CEMVN-CD-NO-Q

18 September 2000

SUBJECT: Contract No. DACW29-99-C-0005, Lake Pontchartrain, Louisiana and Vicinity, London Avenue Outfall Canal, Parallel Protection, Floodproofing of Gentilly Boulevard Bridge, Orleans Parish, Louisiana

**PLAN & PROFILE
NORTH ROADWAY**

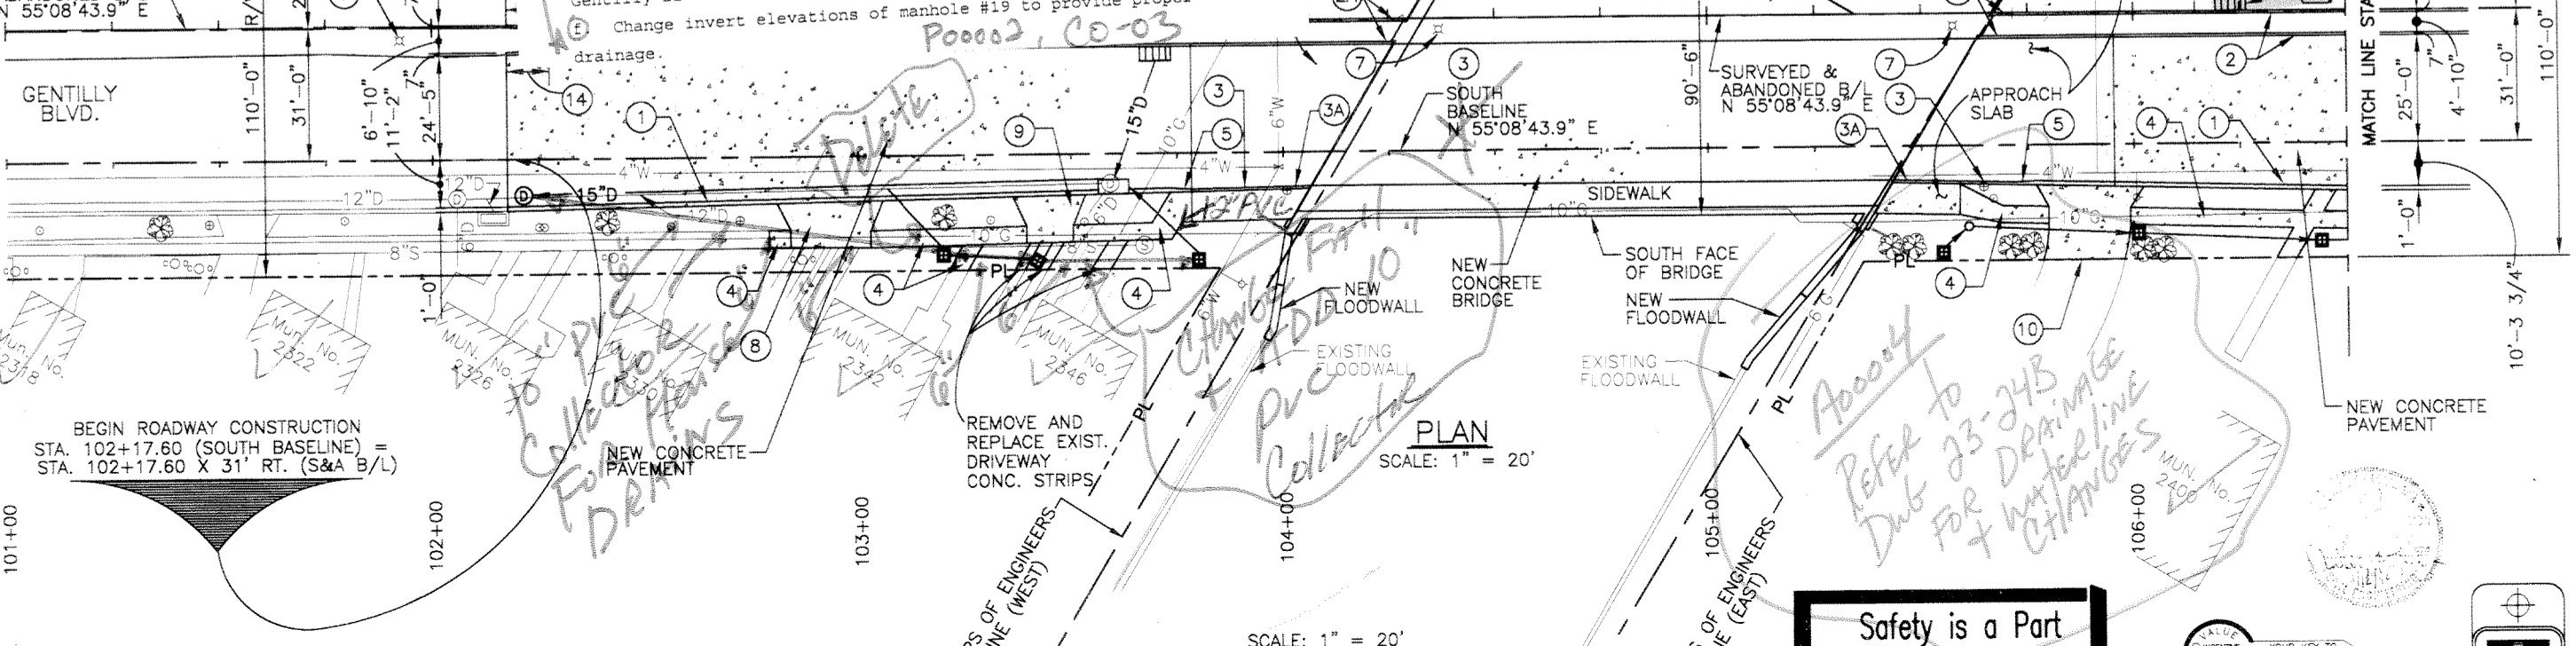
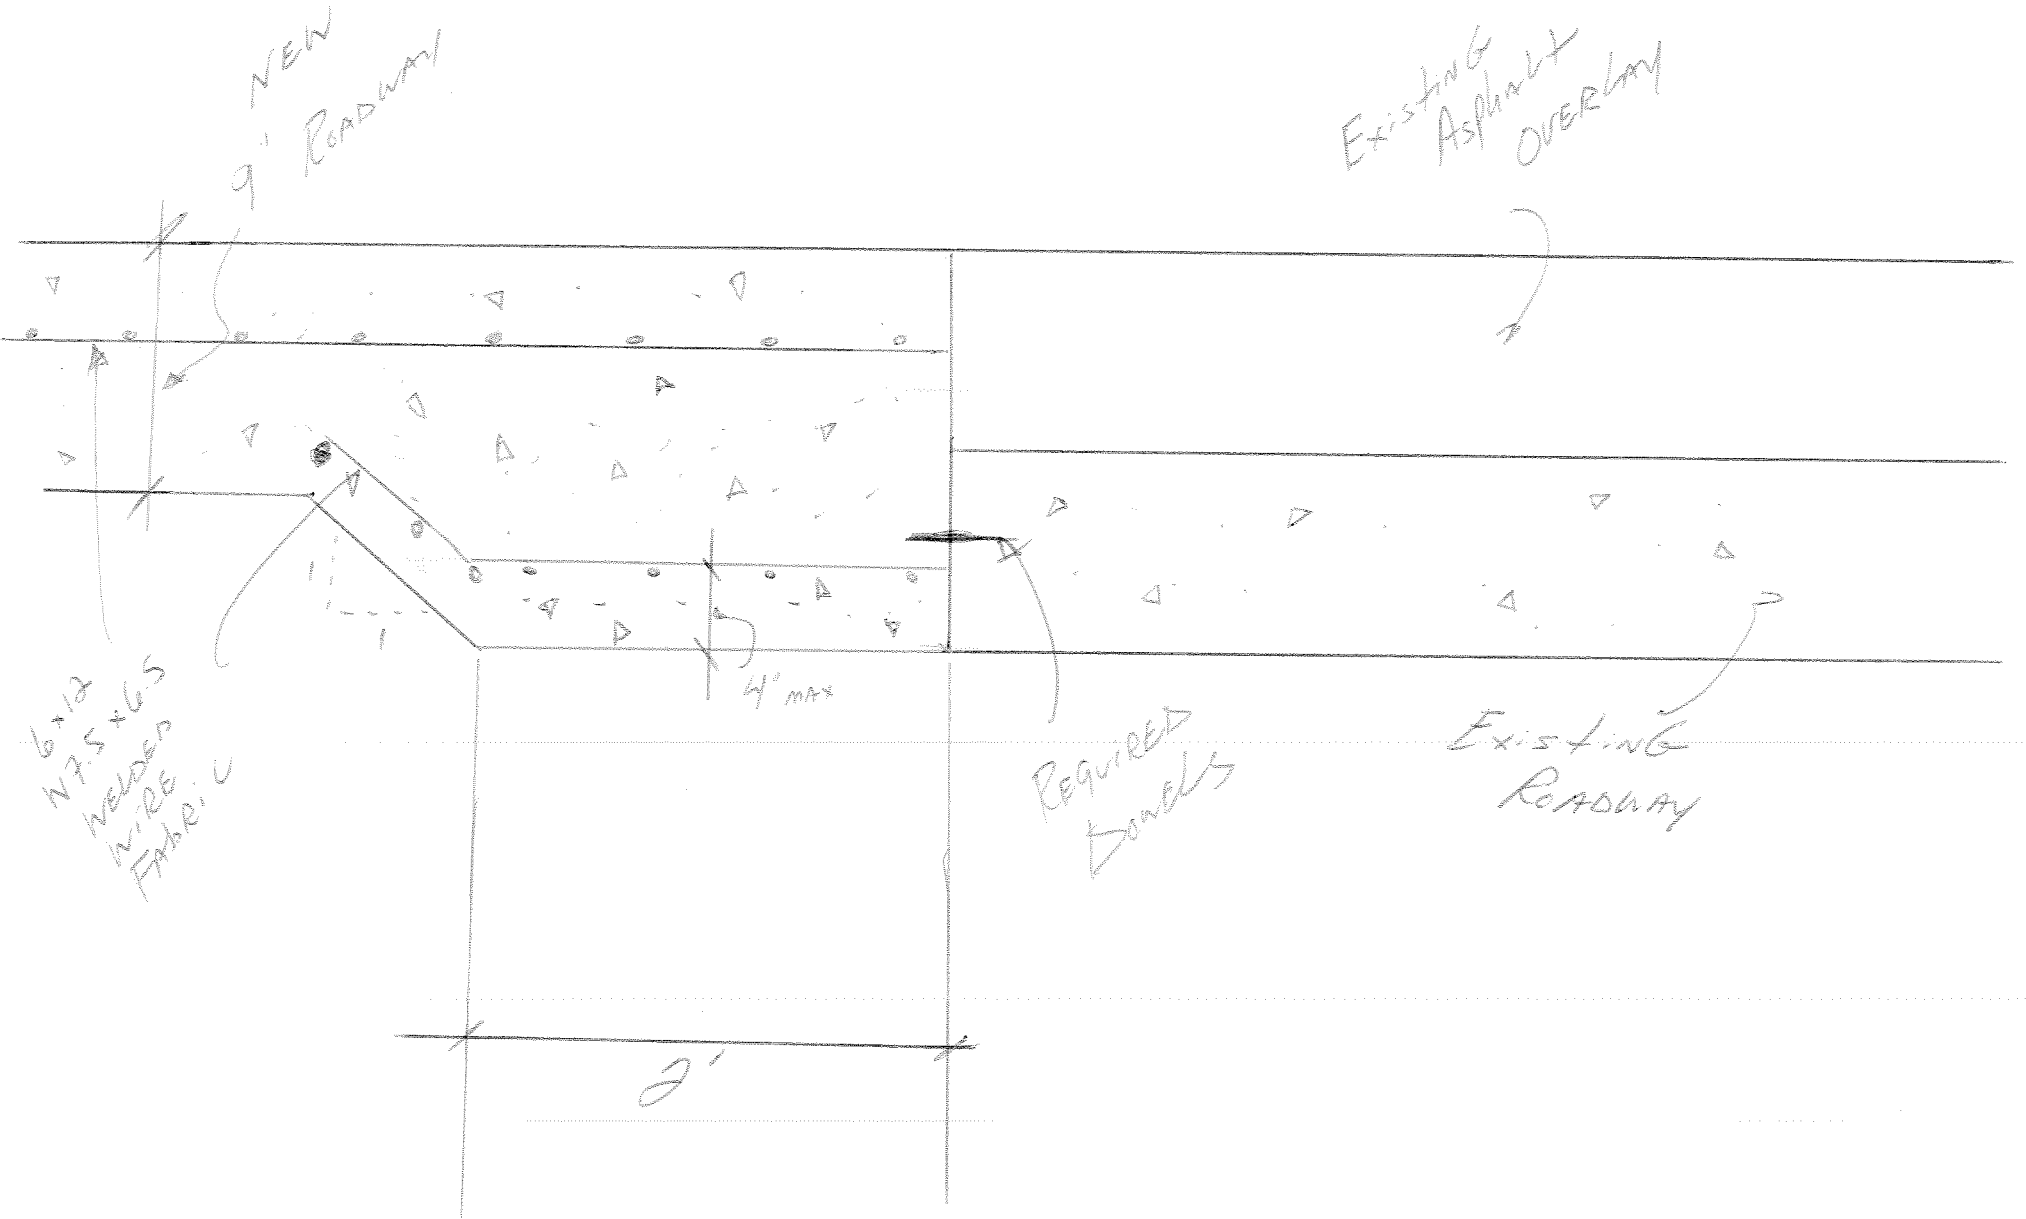
Changes to the Contract Drawings: Make pen and ink changes to drawing & of 67 and 6 of 67 File No. H-4-44733, Plot Date 2/20/98 as follows:

- Plug wye at 18B and delete line between 18B and surface drain #25
- Connect surface drains #25, #27 and #23 with 10 inch PVC pipe; flows go from drain #25 to #27 to #23.
- Connect surface drain #23 to manhole #19 with 12 inch PVC pipe.
- Connect house rain drains from 2342 Gentilly Blvd east side and both drains from 2346 Gentilly Blvd to line between surface drain #25, #27 and #23.
- Provide 10 inch PVC collector line between manhole #25 and manhole #18 for house rain drains from 2342 Gentilly Blvd west side to 2330 Gentilly Blvd.
- Change invert elevations of manhole #19 to provide proper drainage.

** Change Co-03*

Change to PVC collector for drains

ADD 10" PVC collector

Change to PVC collector for drains

Change to PVC collector for drains

Change to PVC collector for drains

Change to PVC collector for drains

PLAN

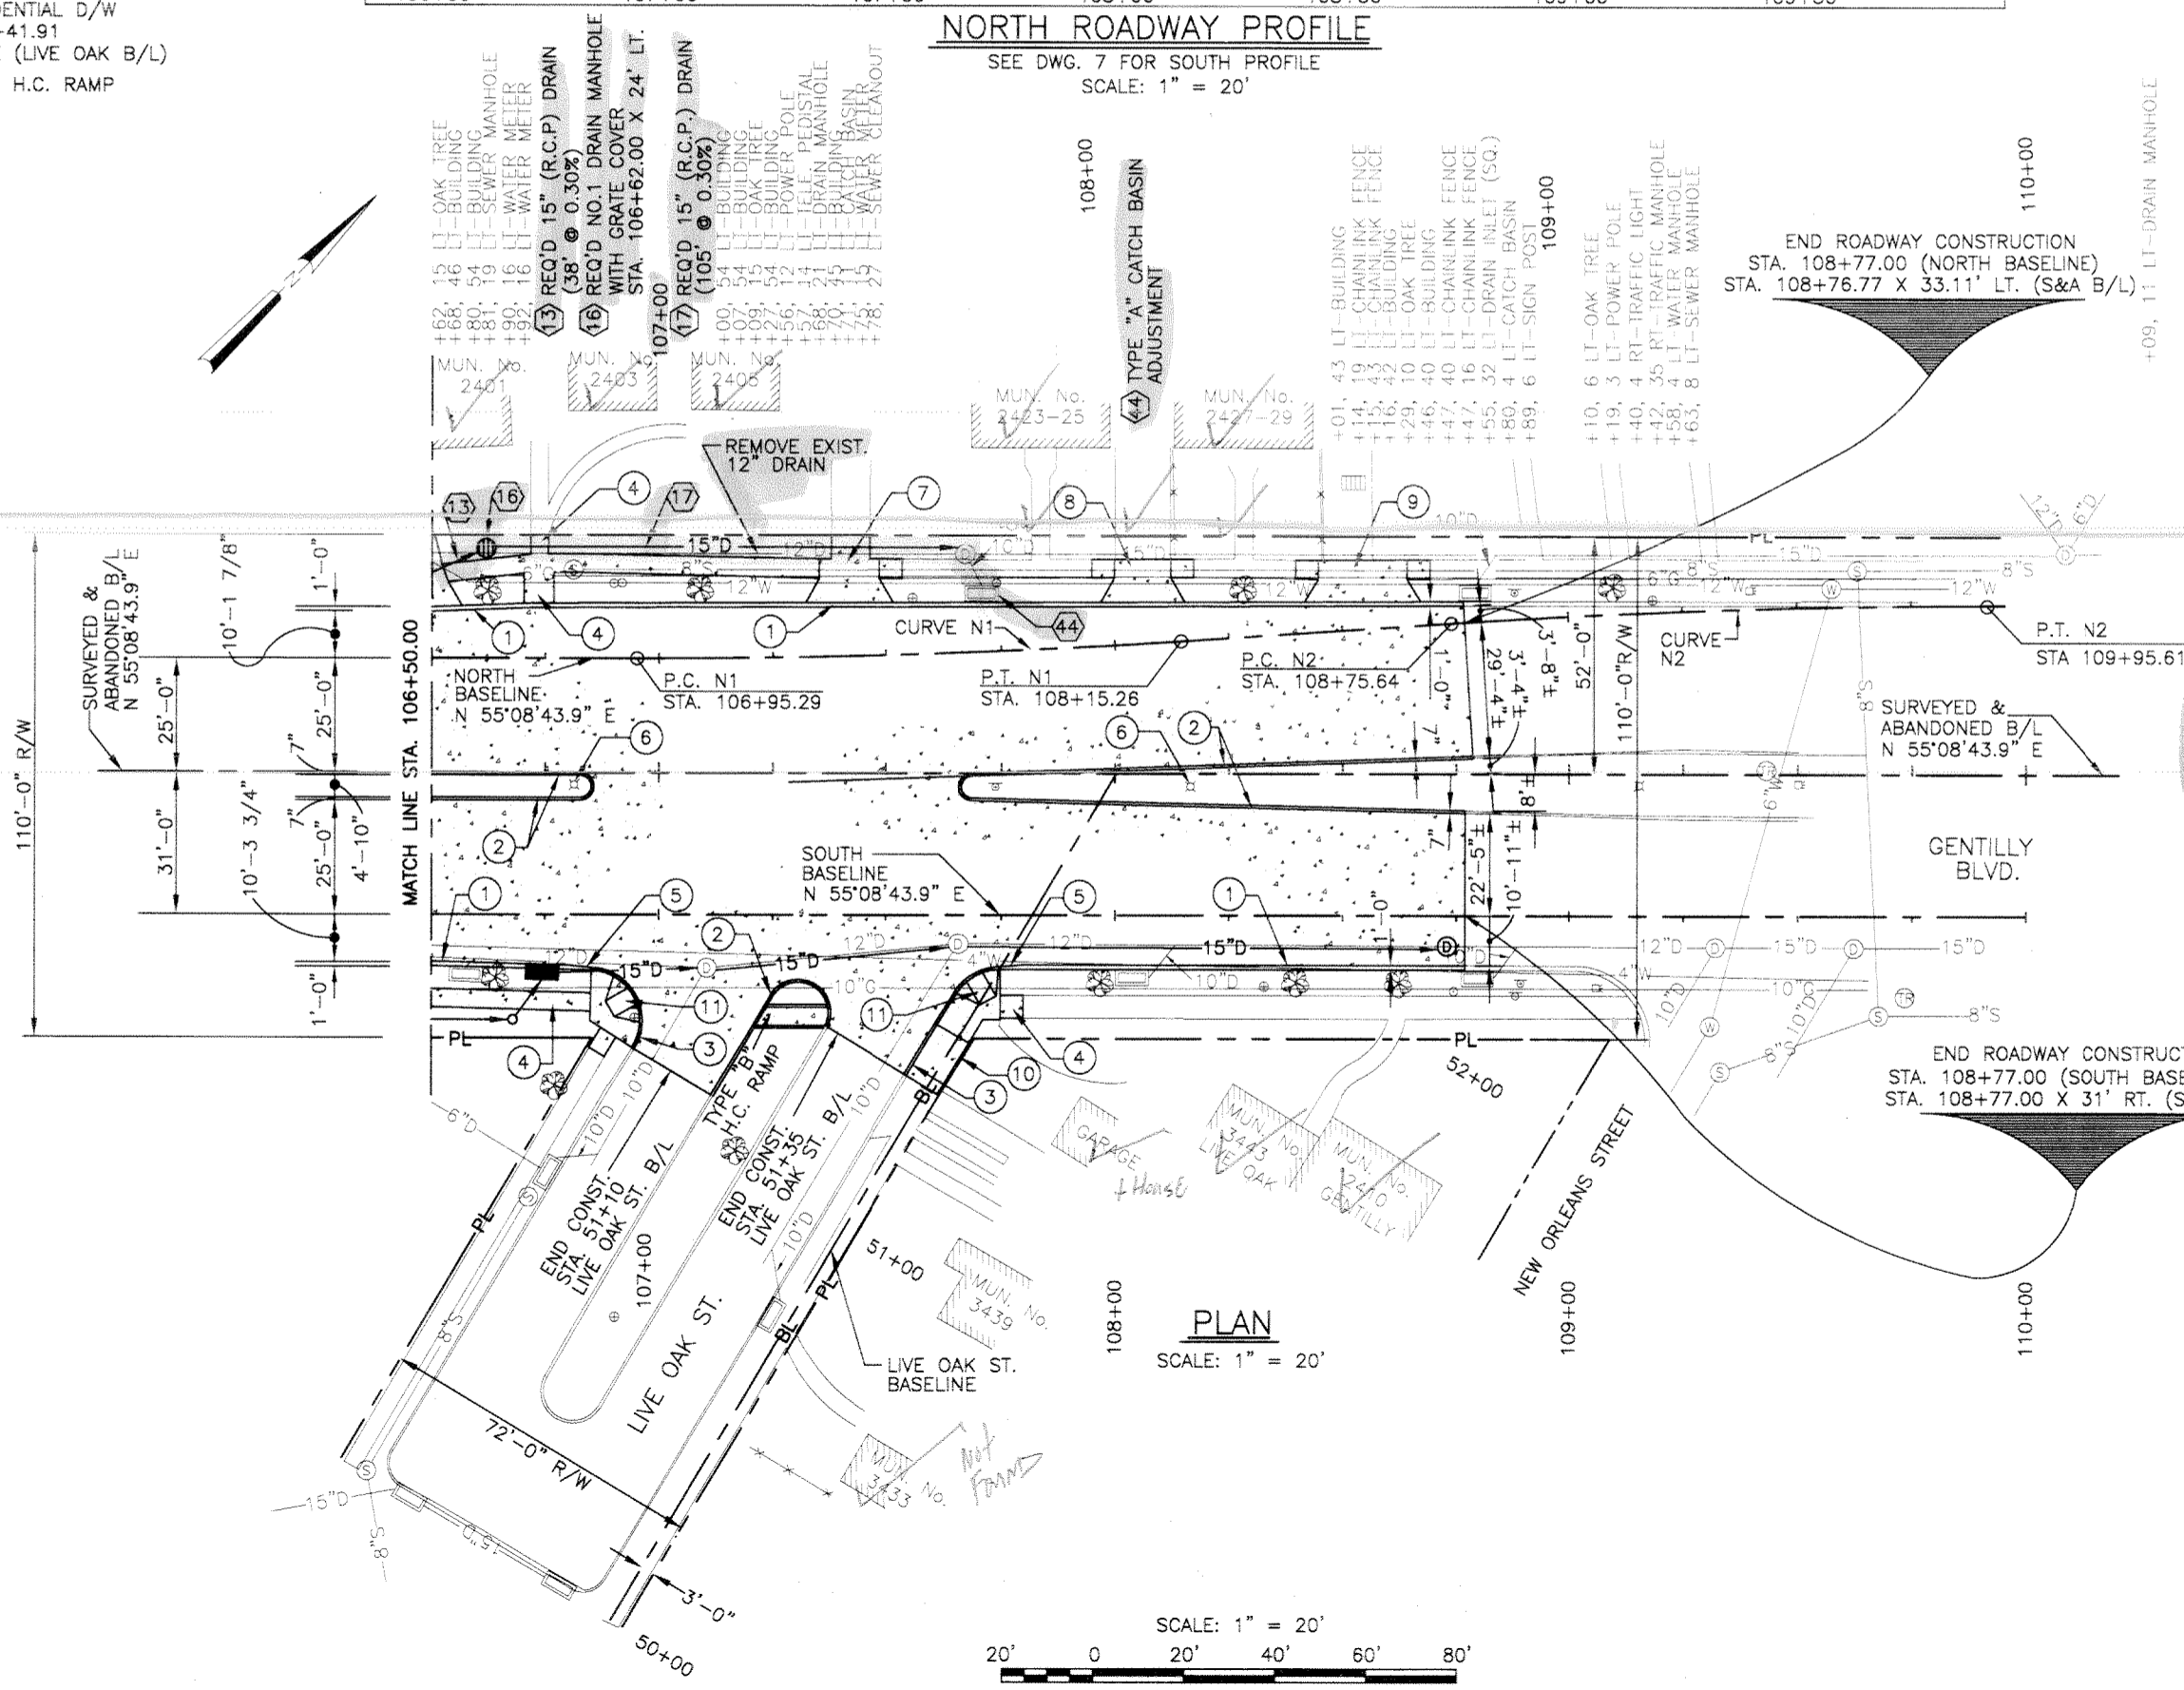
A00004
Refer to DWG 23-24B for DRAINAGE & WATERLINE CHANGES
